SPARANO + MOONEY ARCHITECTURE

ADDENDUM #2

PROJECT:	Caine Lyric Theatre – Fly Loft and Stage Improvements Project	PROJECT NO.	C001541
OWNER:	Utah State University 6550 Old Main Hill Logan, UT 84322-6605	Phone: 435.797.3771 Contact: Thomas Graham	
ARCHITECT:	Sparano + Mooney Architecture 57 West 2100 S Salt Lake City, Utah 84115	Phone: 801.746.0234 Contact: Seth Striefel	
DATE OF ISSUANCE:	April 16, 2025

ROOF PLAN

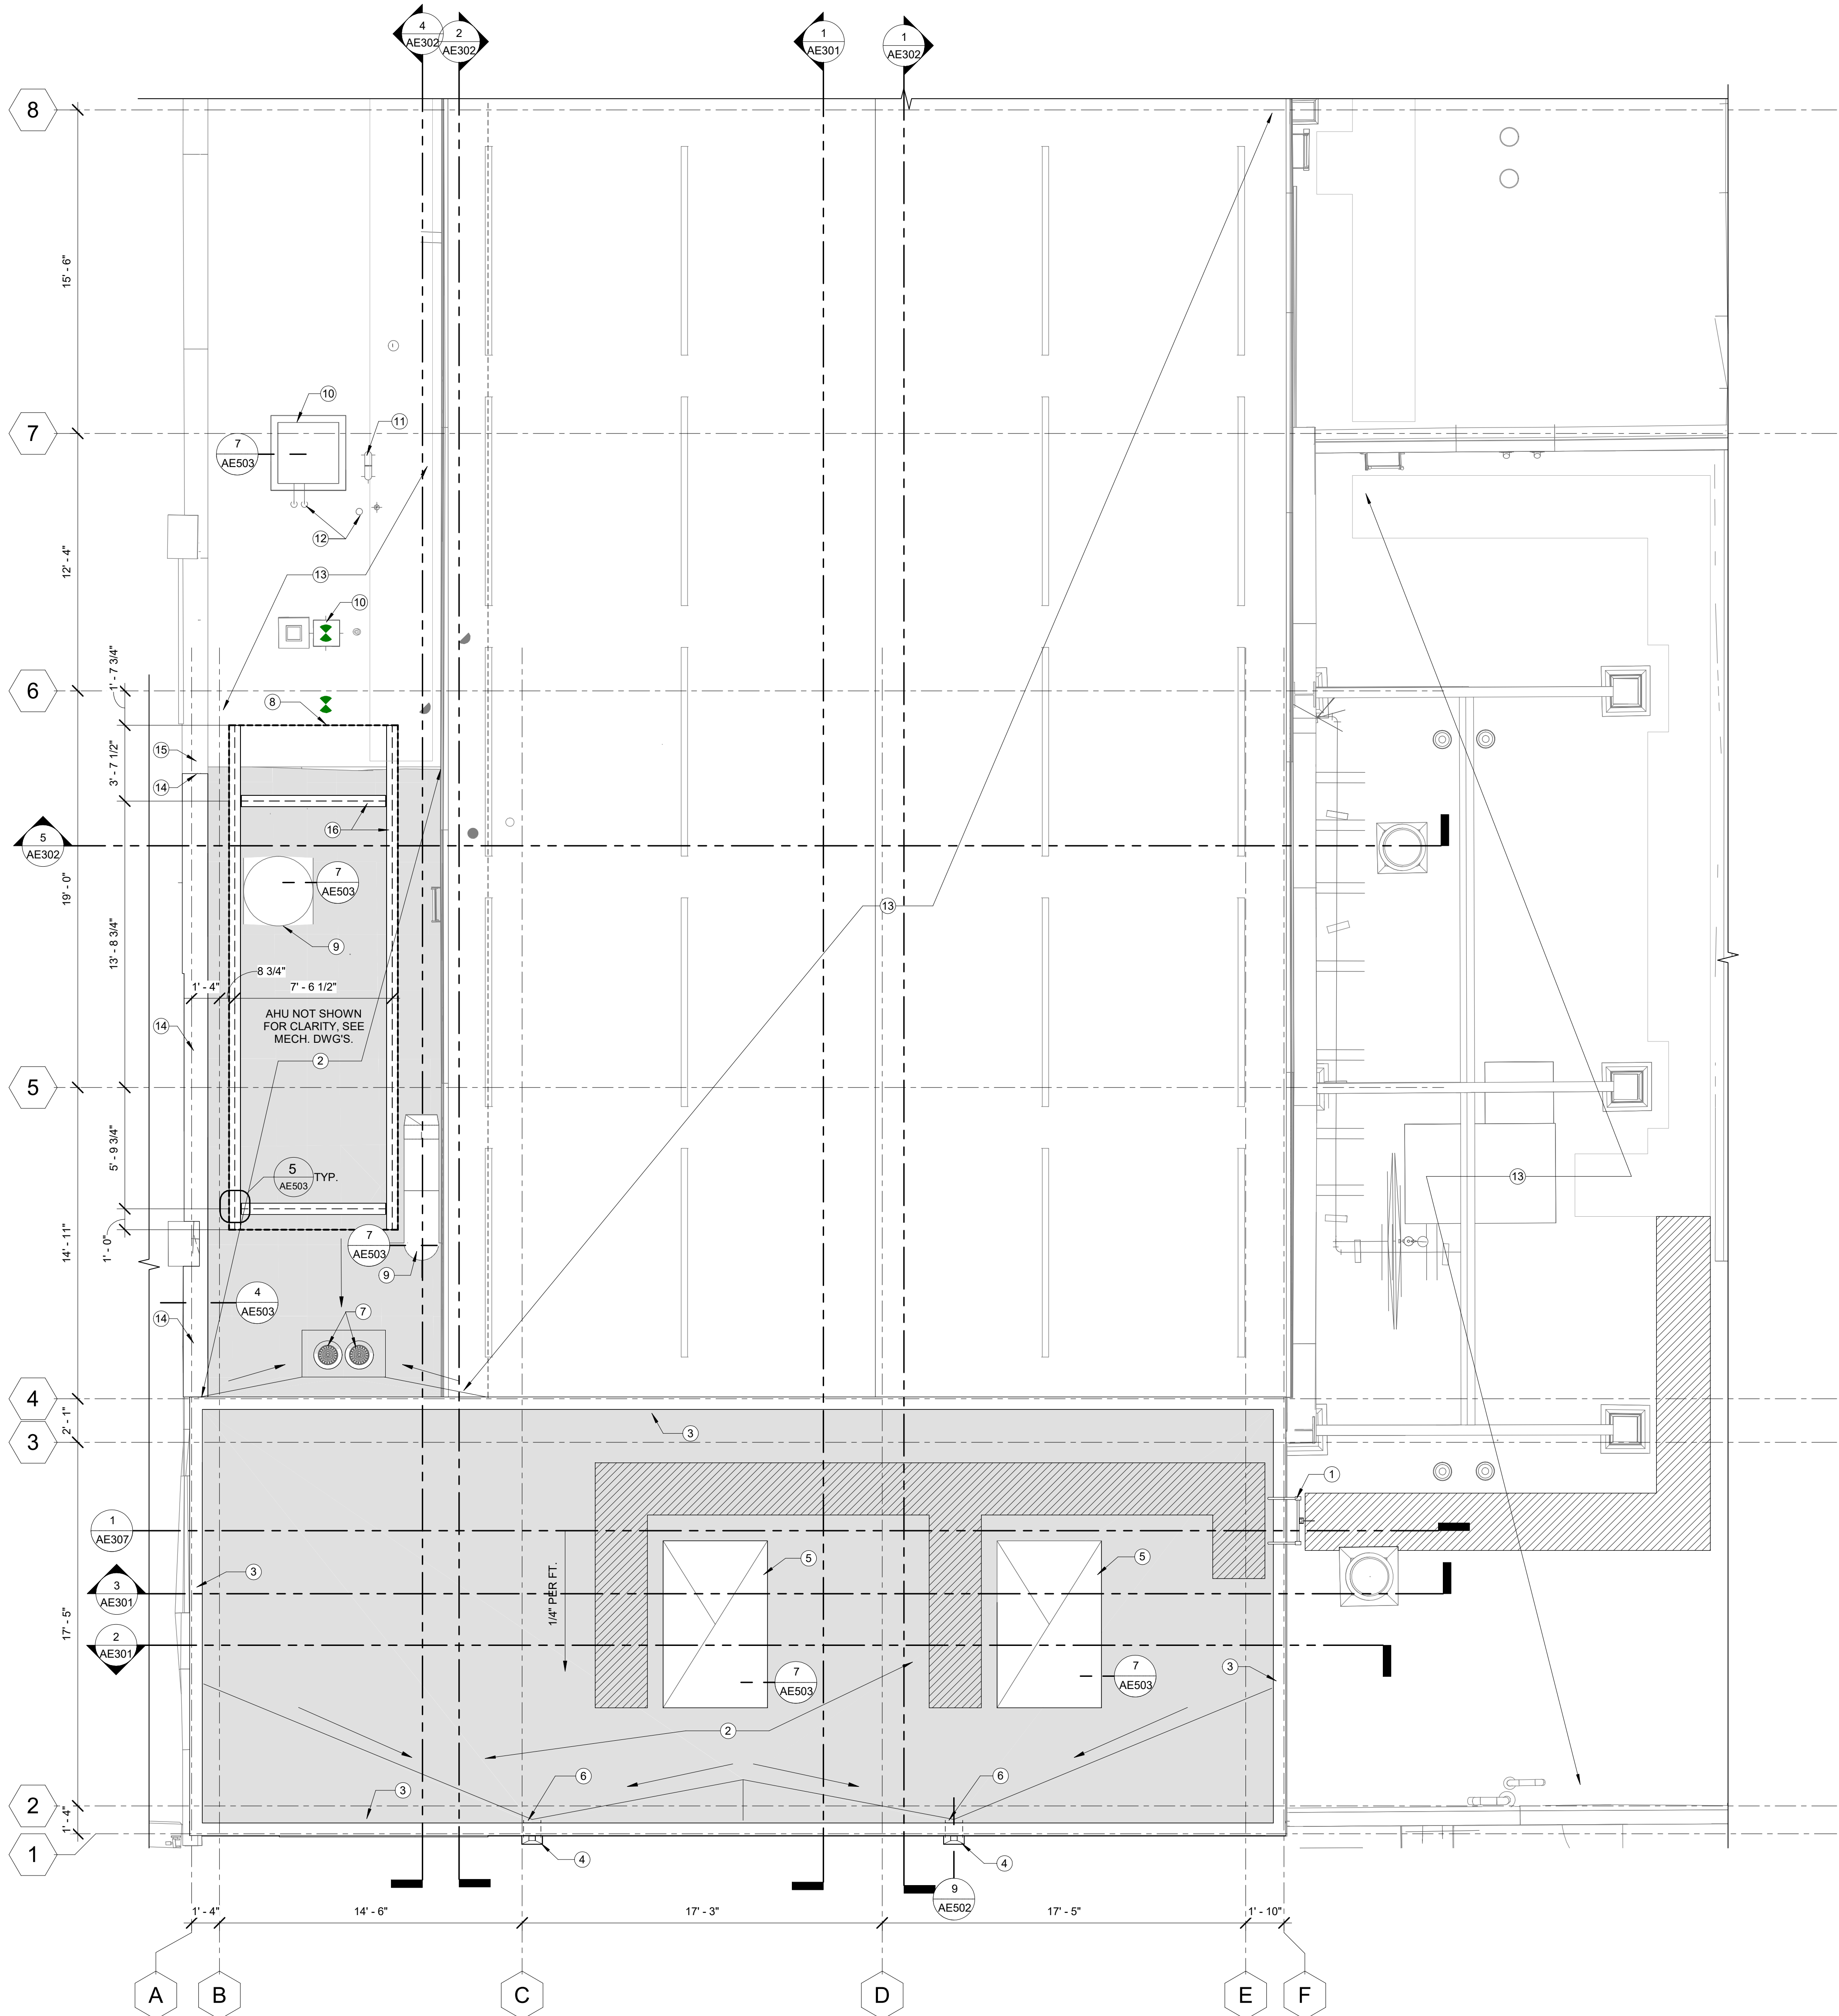
The roofing system is to be mechanically fastened versus fully adhered to match the roofing system installed on the building in 2014. See attached revised specification section 07 5400, and associated drawings noting this revision.

1 FIRE RISER DETAIL

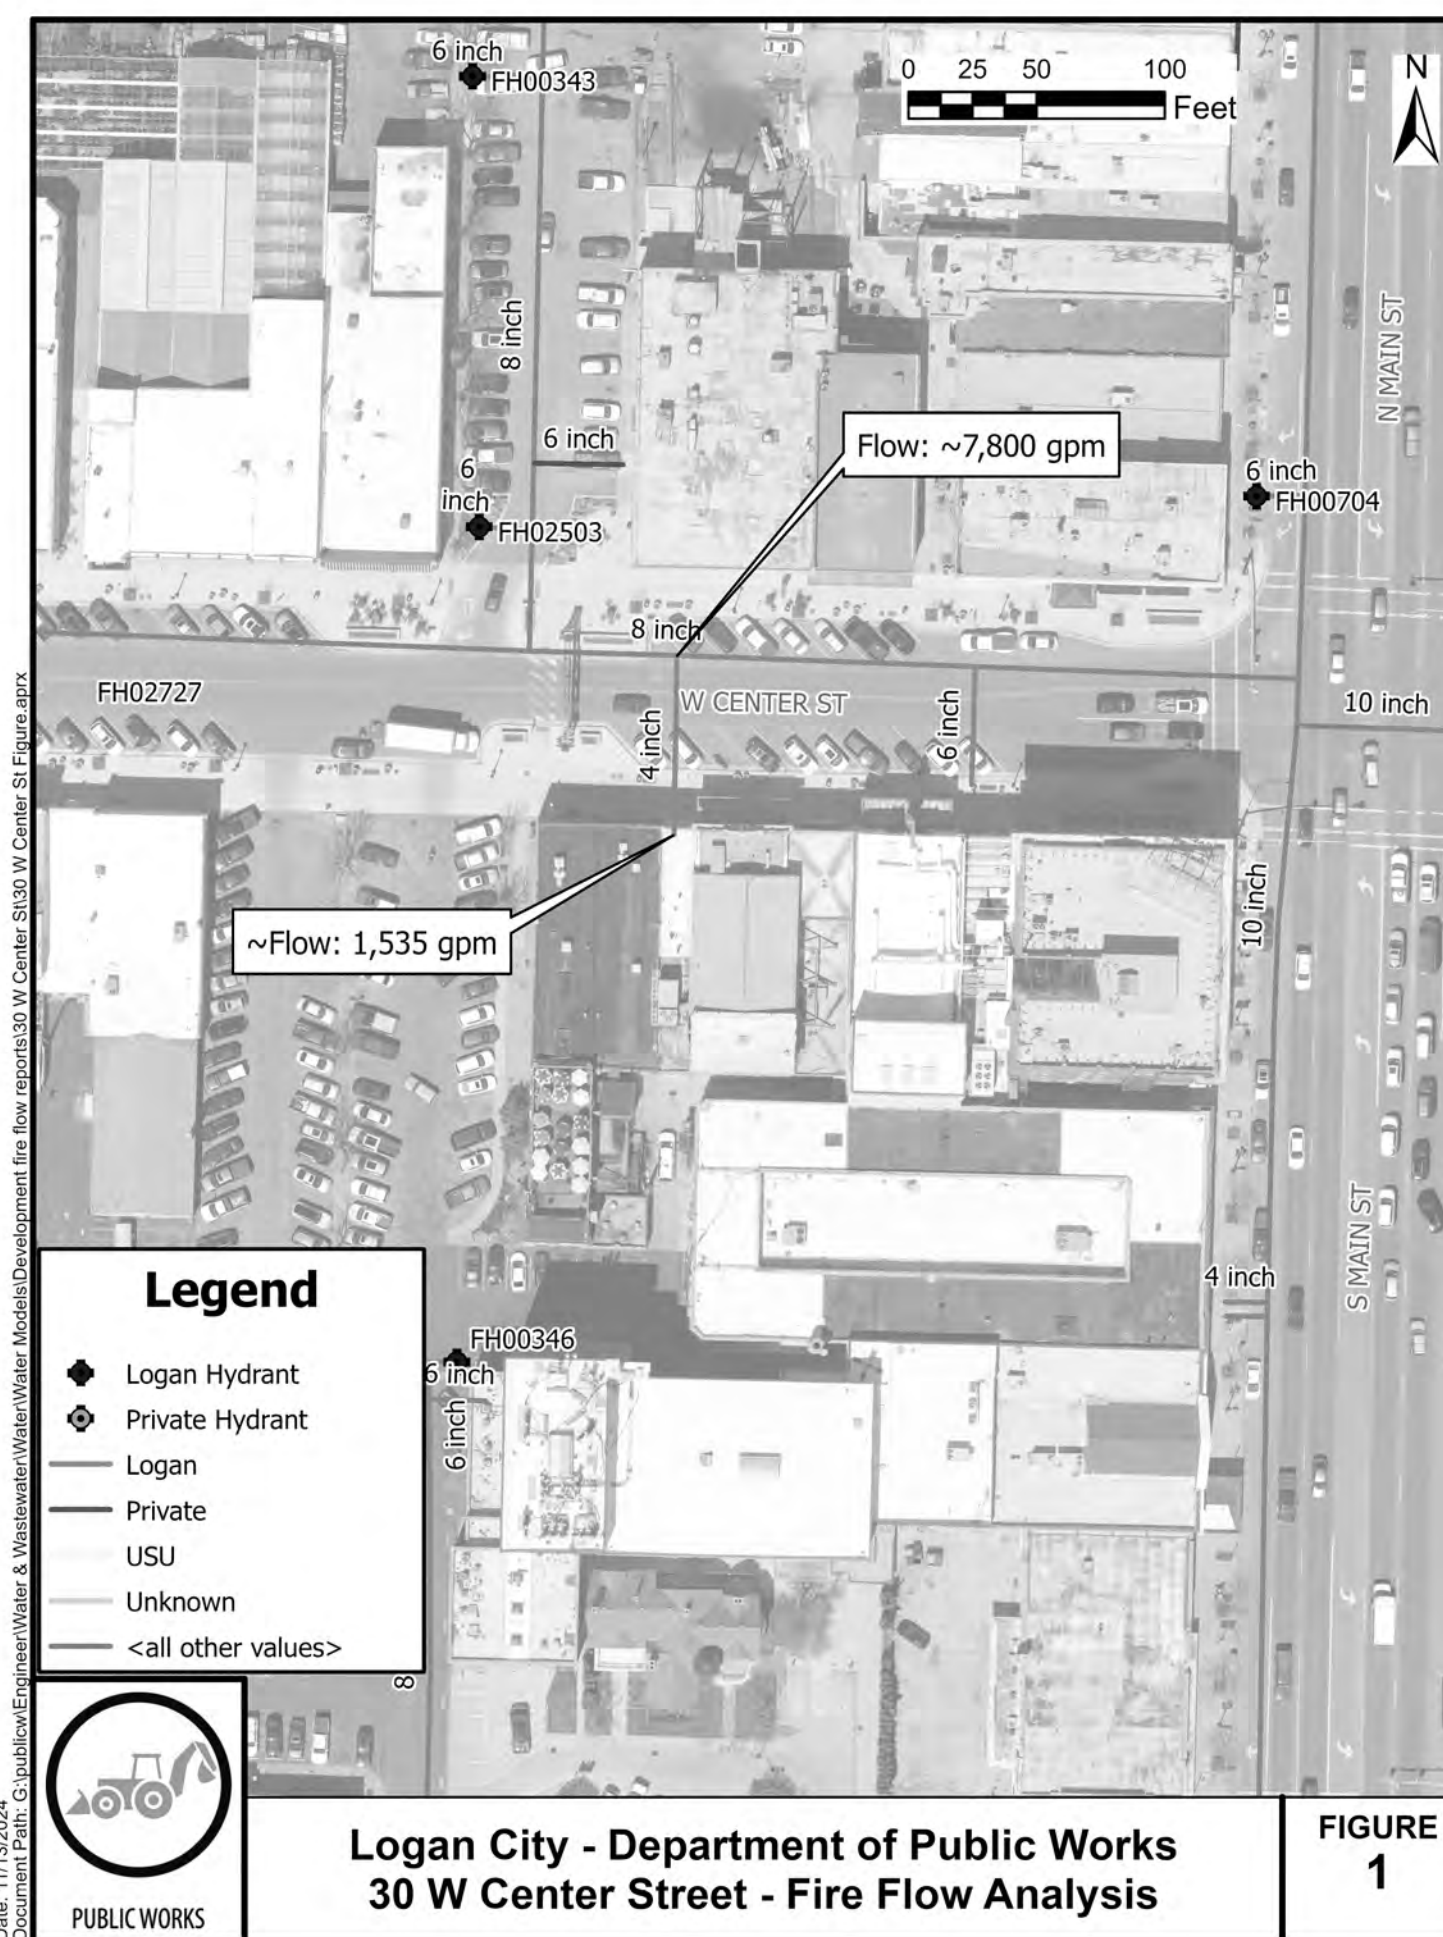
F. *Sheet F501 wet riser keyed notes #12 and #16 are typed over. Please clarify.*

Response: See updated and attached drawing sheet F501 with issue resolved.

1 ELECTRICAL SITE PLAN

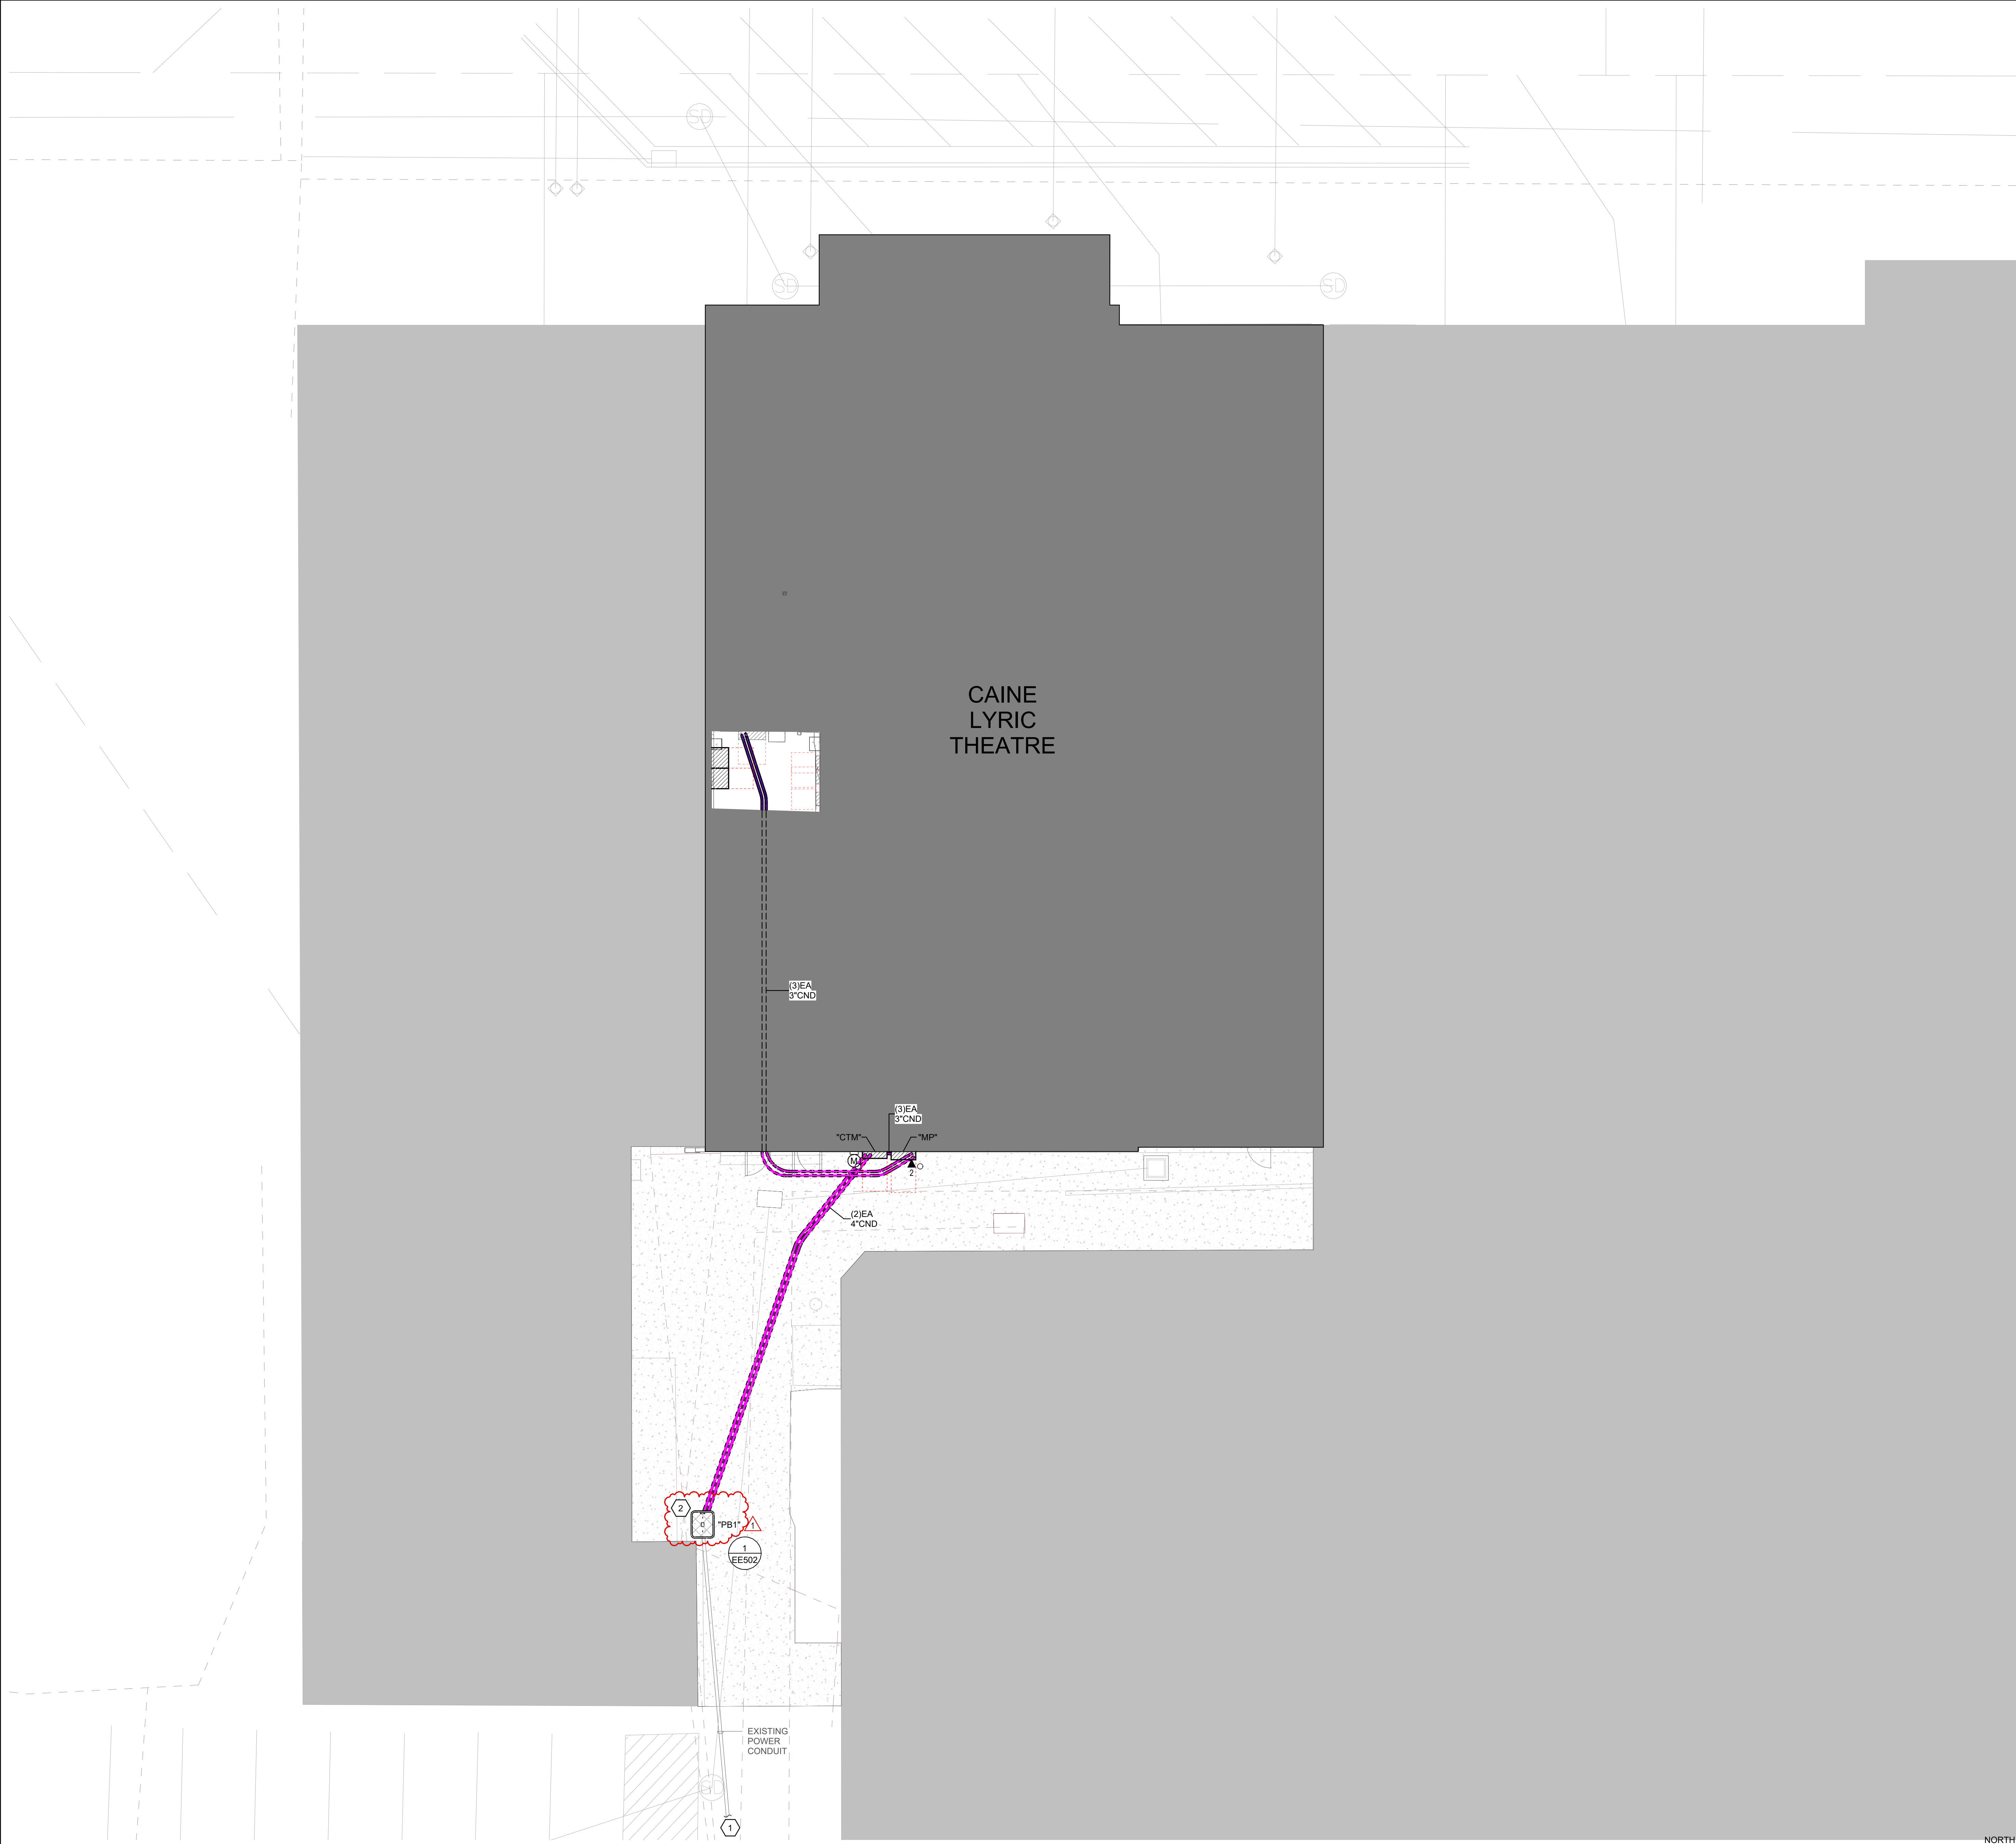
1. ES101 – Relocated pull box “PB1”. See attached sheet.
2. ED101 – Revised sheet keyed note #4. See attached sheet.
3. ED104 – Added j-box for demolition on roof. See attached sheet.
4. ED301 – Revised notes on Existing South Exterior Wall Elevation View3. See attached sheet.
5. EP103 – See attached sheet for the following:
 - a. Added sheet keynote #2.
 - b. Added junction box for IT network.
6. EP651 – Revised Telecom Conduit Riser Diagram. See attached sheet.
